Subject: Interstate 4 from 1 Mile East of State Road 434 to Volusia County Line Value Engineering Study Recommendation Dispositions

FM: 242592-4

Interstate 4 from 1 Mile East of State Road 434 to Volusia County Line

Value Engineering Study **Draft** Report

RECOMMENDATION No. 8: Add direct connect ramps to the express lanes at EE Williamson

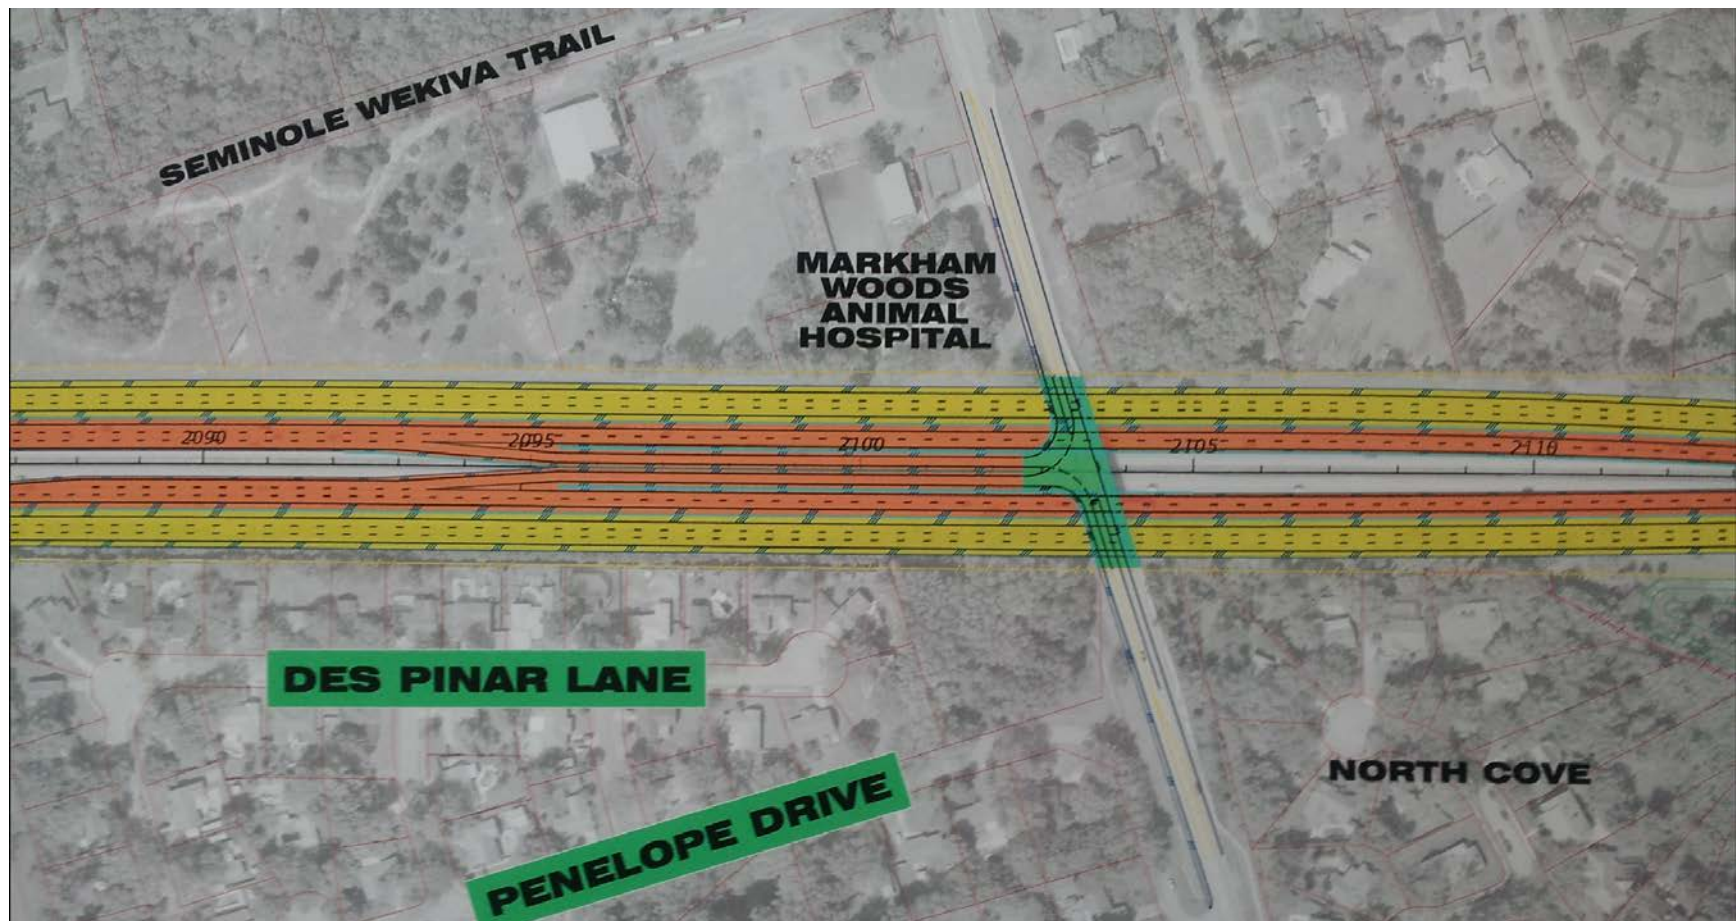
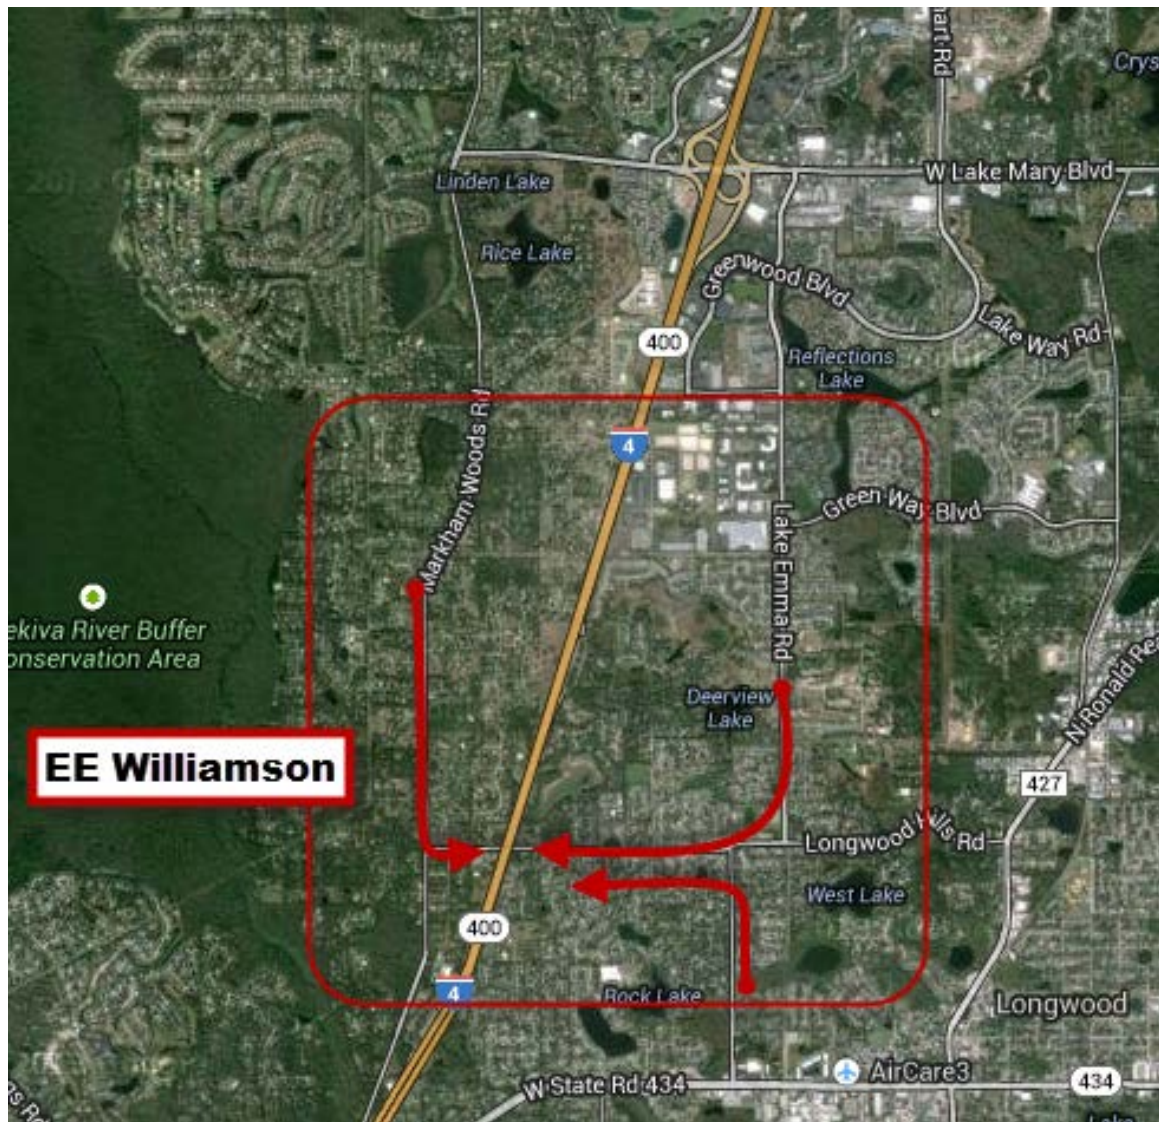
The PD&E Documents show entry and exit points for the express lanes approximately 2 miles west of the Lake Mary Boulevard Interchange, 1.2 miles east of the Lake Mary Boulevard Interchange, and at the SR 417/Wekiva Parkway Interchange.

Not Accepted. Coordination with Seminole County occurred, as well as a public meeting to local residents, and this idea was dismissed due to significant opposition. A traffic study was also performed to evaluate the operations, and the results were there was little benefit to the operations of I-4.

RECOMMENDATION No. 11: Provide a grade separated intersection at Lake Mary Blvd & Primera Blvd/ Lake Emma Rd

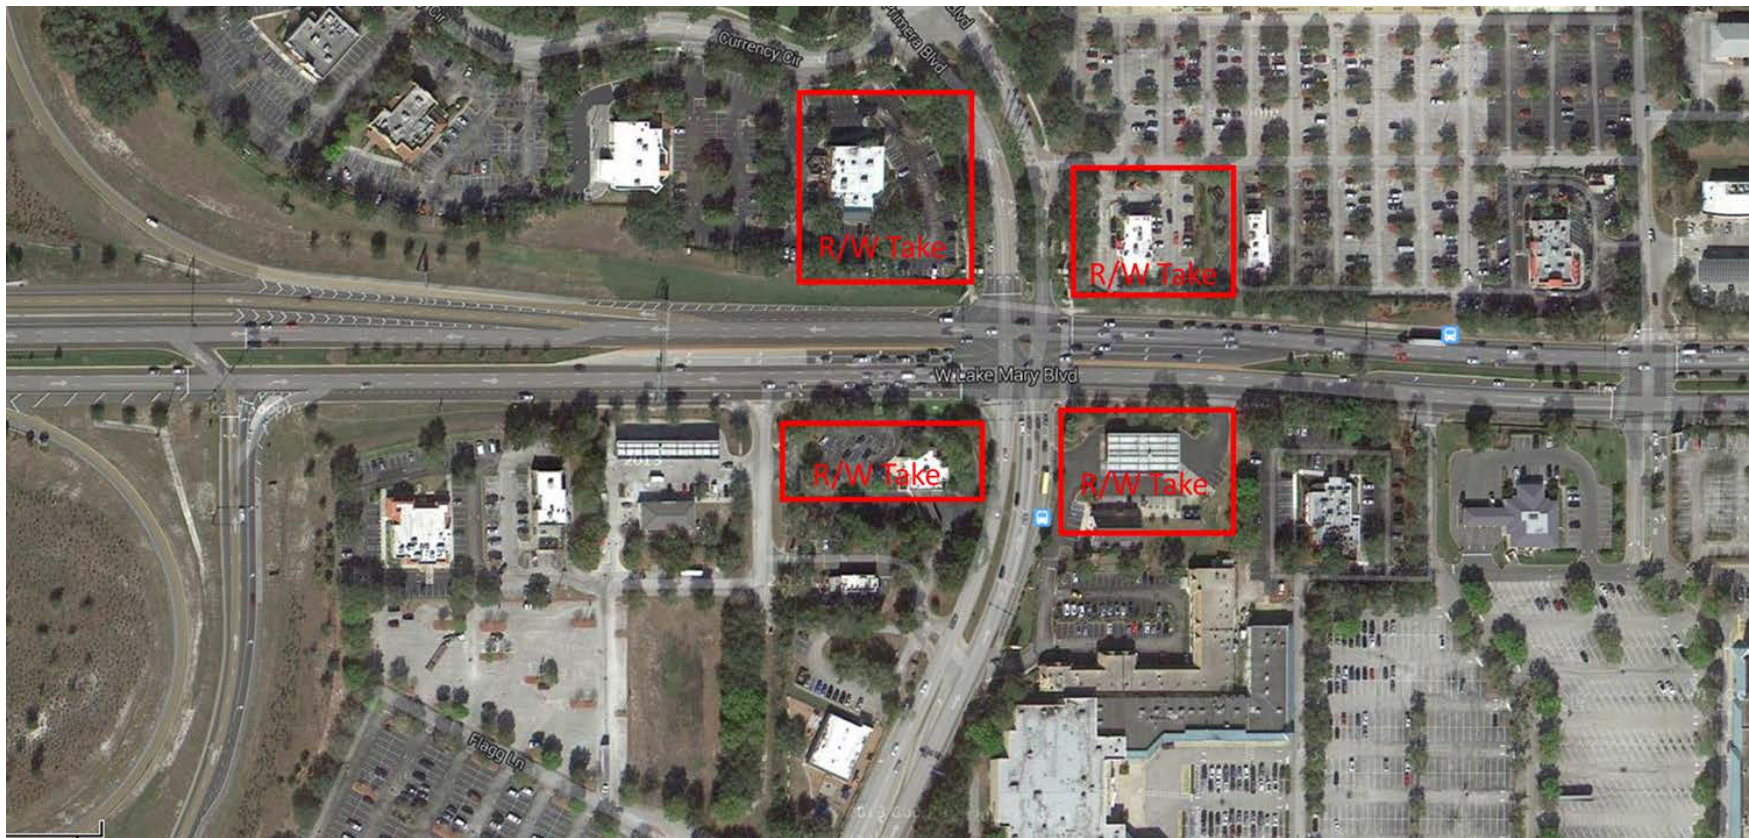
The PD&E Documents show no changes to the intersection of Lake Mary Blvd. and Primera Blvd./Lake Emma Rd.

Not Accepted. A grade separated intersection at this location would cause numerous access issues to the east of the intersection. In the current year and the future design year, traffic does not back up onto the I-4 mainline.

RECOMMENDATION No. 12: Corridor improvements on Lake Mary Blvd from the I-4 interchange to Rinehart Rd

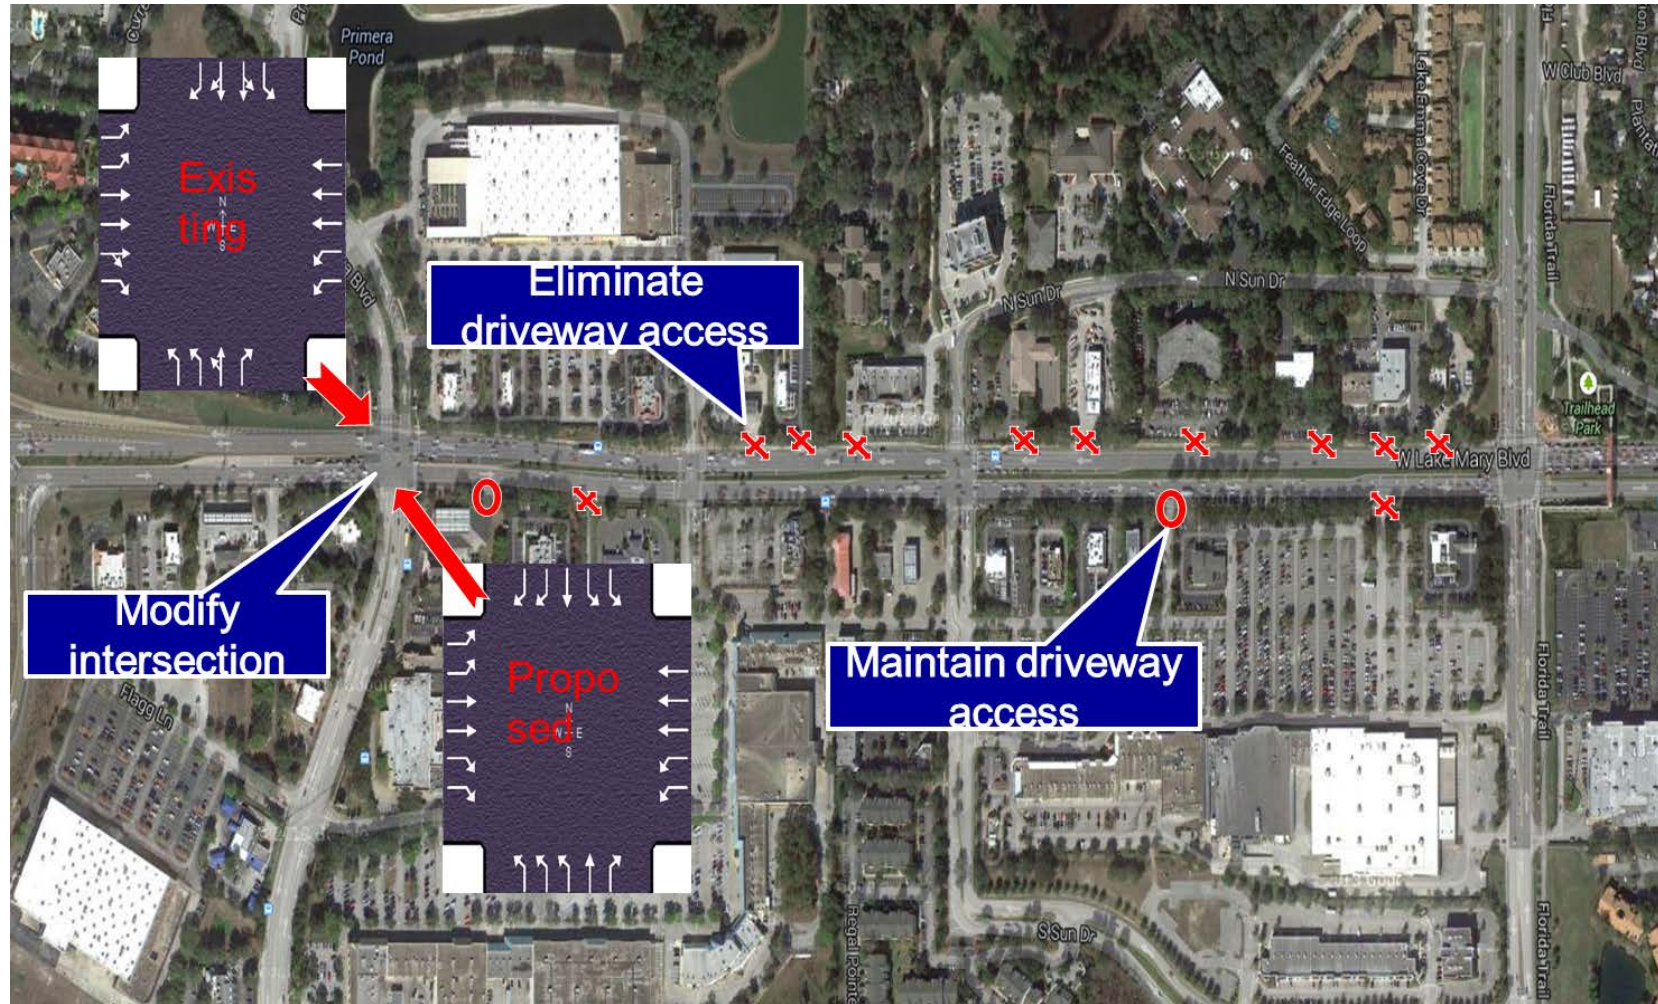
The PD&E Documents show no changes to the Lake Mary Blvd. corridor.

At Primera Blvd./Lake Emma Rd. modify the intersection to add a right turn lane for northbound Lake Emma Rd. Additionally convert the existing right turn lane into a through lane and make the three left turn lanes dedicated left turns. On Primera Blvd. convert the through-left to a dedicated left turn lane and add a through lane. Remove all driveways between Primera Blvd. and Rinehart Rd on Lake Mary Blvd. These businesses can be accessed through the existing frontage roads.

Accepted. The traffic modelers are looking at what kind of improvements can be made throughout the corridor.

RECOMMENDATION No. 14: Construct a pedestrian tunnel under ramps and bridge over the mainline on the north side of Lake Mary

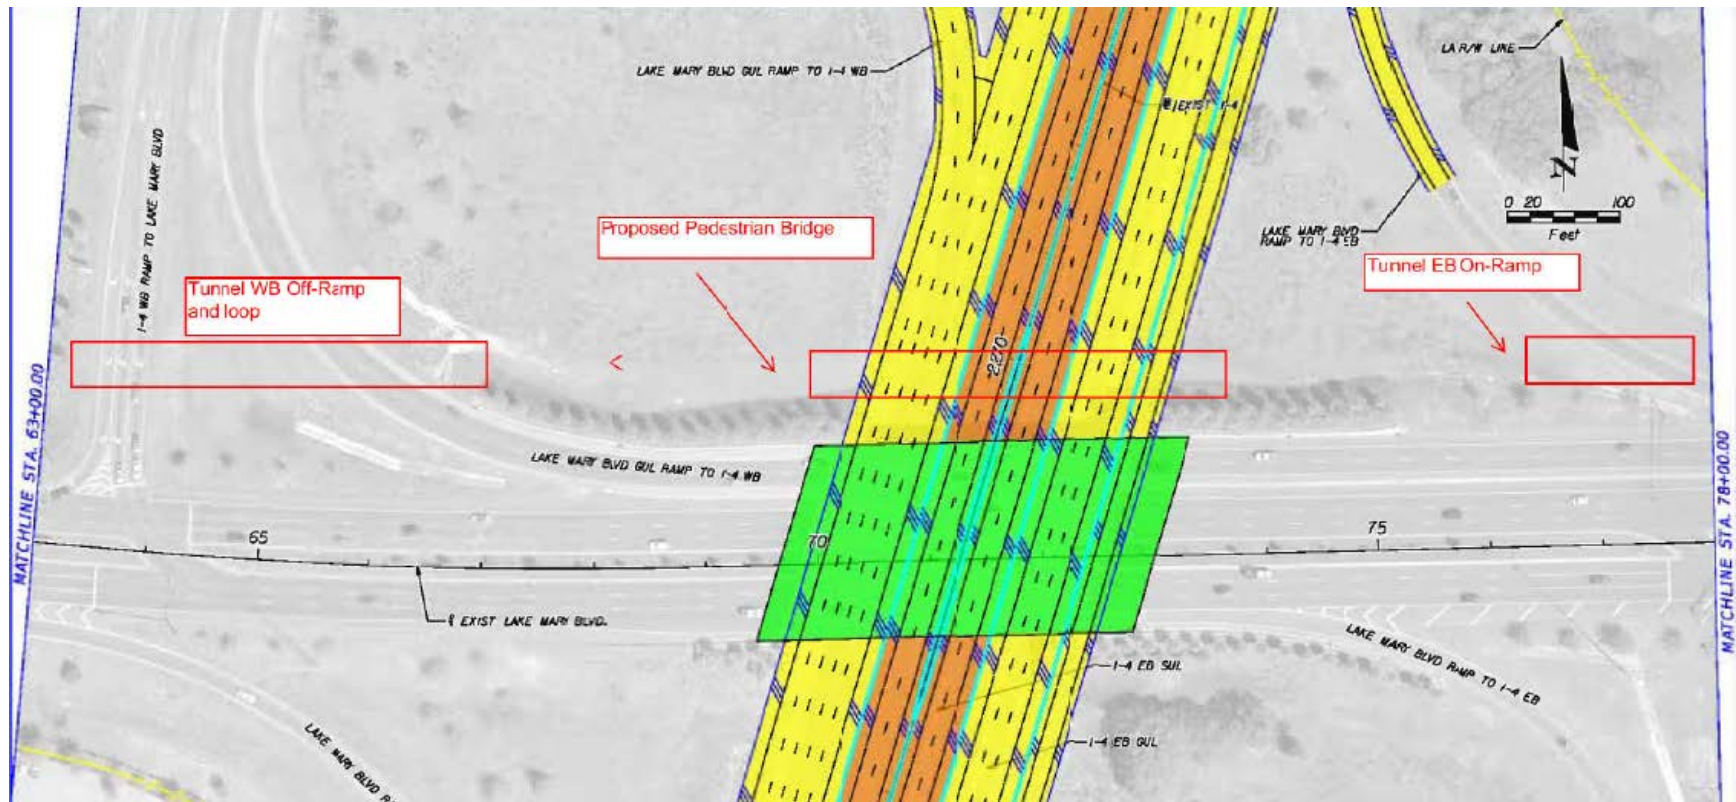
The PD&E Documents show the pedestrian route as being on the westbound side of Lake Mary Boulevard. There is an at-grade one-lane crossing at the eastbound I-4 on ramp. The sidewalk then follows LMB to a point a few hundred feet from the bridge to an at-grade two-lane crossing of westbound Lake Mary Boulevard. There is no signal at this crossing. The pedestrian lane is located in between the double westbound lanes and the rest of the lanes on the Lake Mary Boulevard Bridge. Once off the bridge the sidewalk continues on until it crosses the three lanes of the westbound I-4 off-ramp to Lake Mary Boulevard. There are two left turn lanes and one right turn lane separated by a refuge island.

Not accepted. It may be possible to tunnel under the ramps, but then the sidewalk would need to get up and over I-4 all while still meeting ADA requirements.

RECOMMENDATION No. 17: Eliminate the right turn lane at International Drive because the outside lane becomes a right turn lane at the intersection

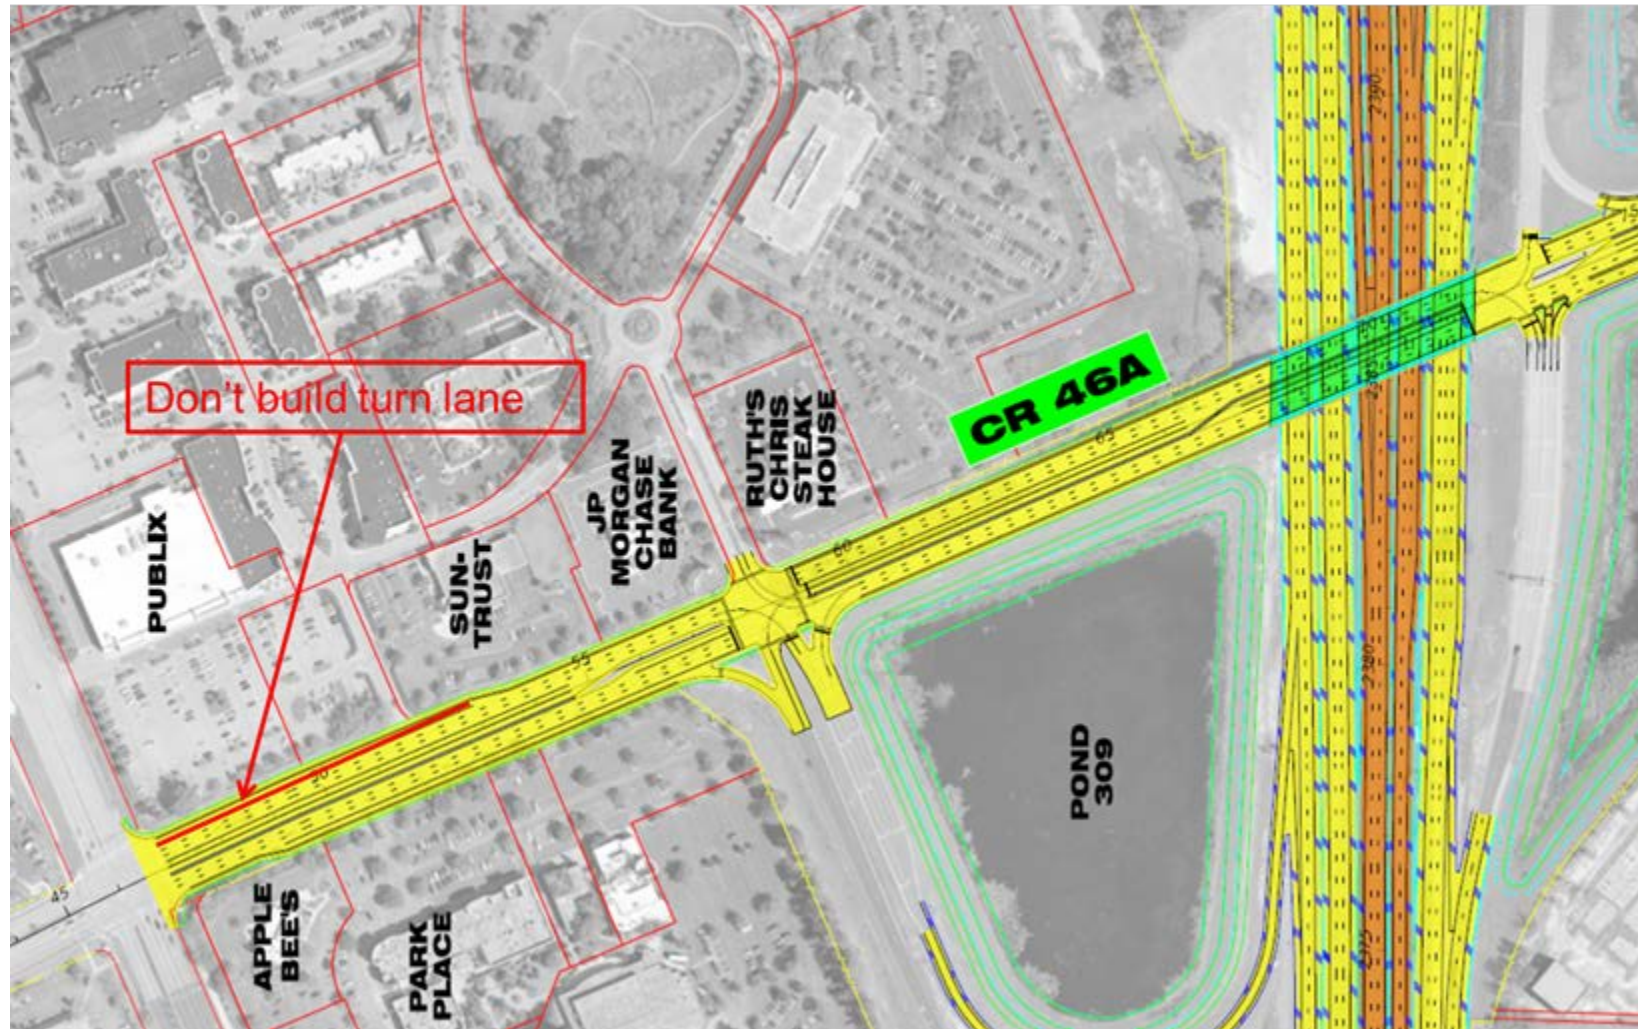
The PD&E Documents detail the construction of a right turn lane on CR 46A in the westbound direction to the intersection of International Parkway.

Accepted. The additional right turn lane at International Parkway will be removed.

RECOMMENDATION No. 18: Start the second eastbound left to eastbound I-4 after the westbound I-4 on ramp so the shift is under and before the overpass

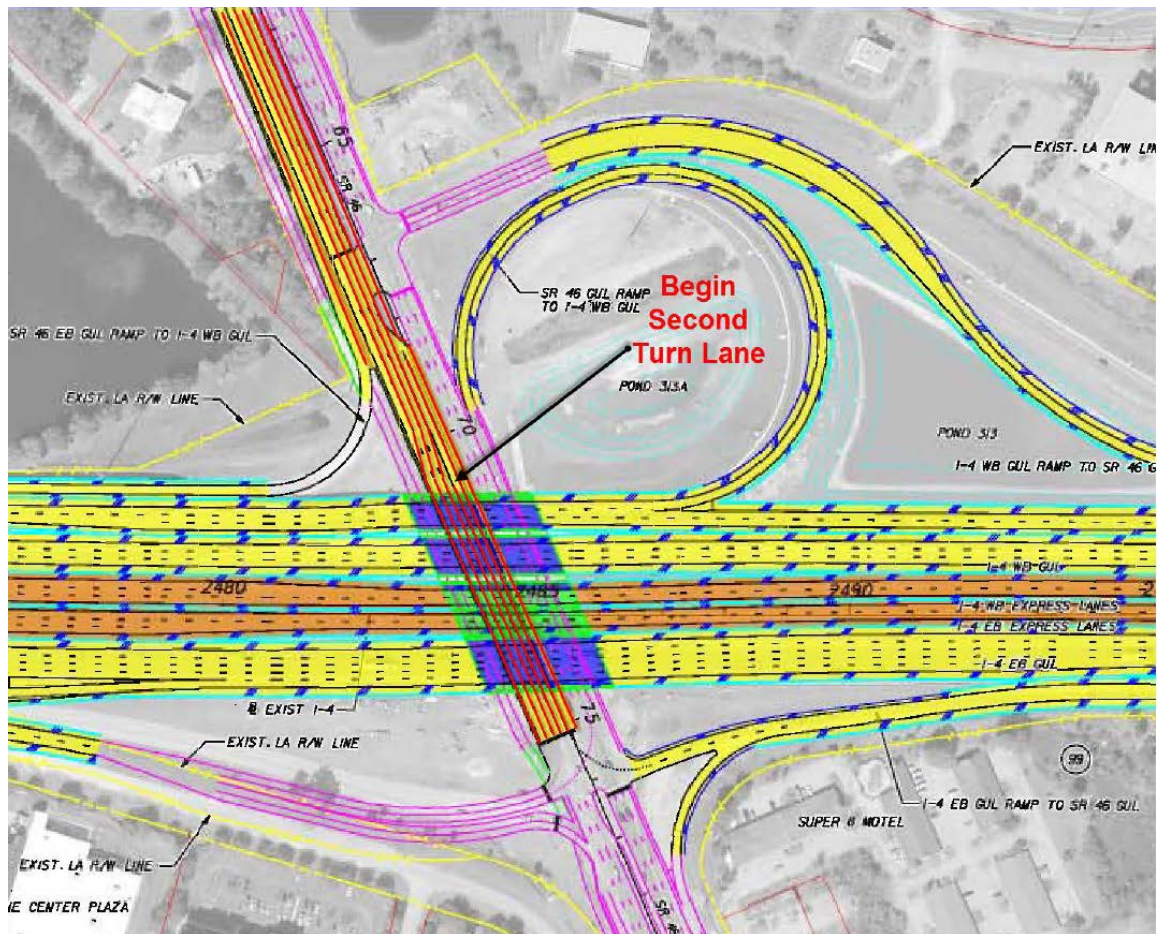
The PD&E Documents show that the SR 46 and I-4 eastbound ramp terminal intersection will be changed so that there are two left turn lanes the same length as the existing left turn lane from SR 46 eastbound onto I-4 eastbound and will continue to have three through lanes.

Accepted. We will revise the amount of turn lane storage and model it to make sure there are no issues.
